# Planning & Zoning Commission

Thursday, February 1, 2024

## MIDWESTERN AUTO GROUP 23-138INF

### Case Summary

#### *Thoroughfare Plan*

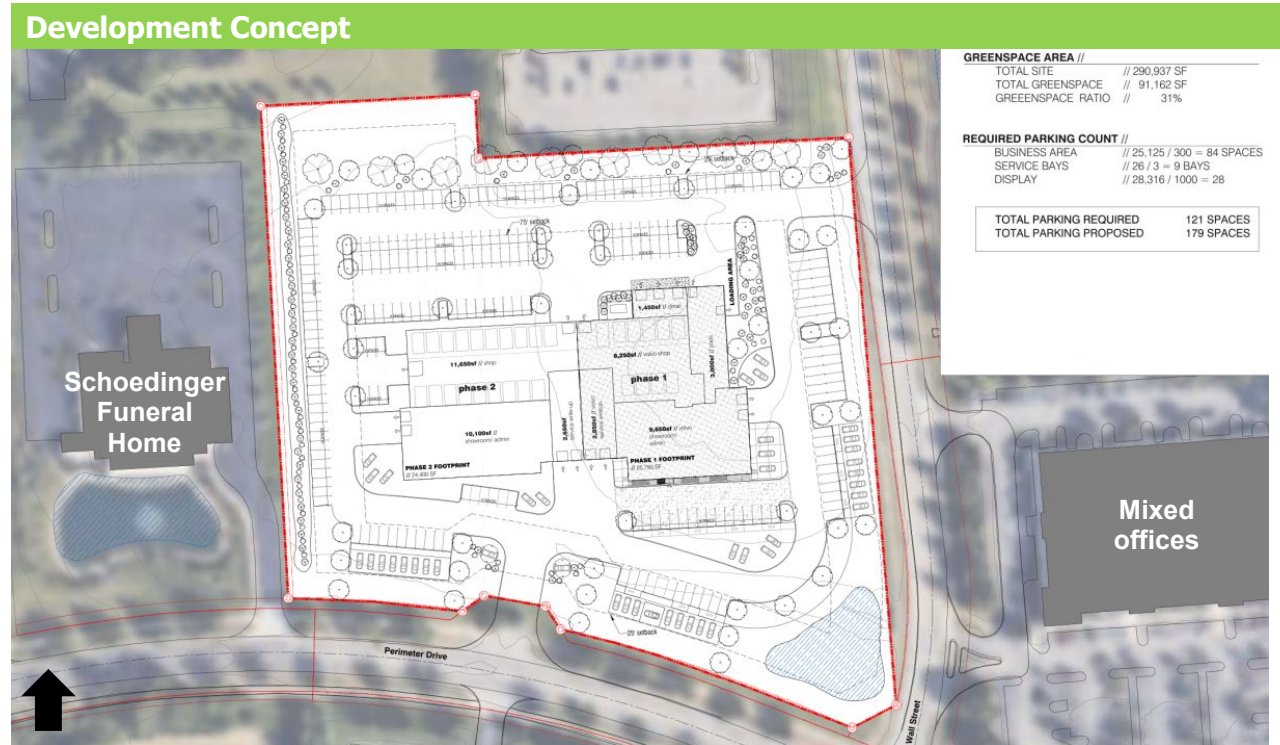
The Thoroughfare Plan is a section of the Community Plan that identifies needed improvements to the existing roadway network and future roadway connections. The existing roadway network surrounding the site has frontage on Perimeter Drive (100' ROW) and Wall Street (60' ROW). Perimeter Drive is a Minor Arterial with traditional roadway character that emphasizes access to land uses. Existing access to the site is provided on Perimeter Dr. The proposed curb cut on Wall Street would continue to be looked at through the PUD process and Rezoning.

A Traffic Impact Study is required when a property is rezoned. From a traffic perspective, if the proposed zoning is less dense or intense than the existing zoning then the applicant should provide a memo documenting the reduction in trips.
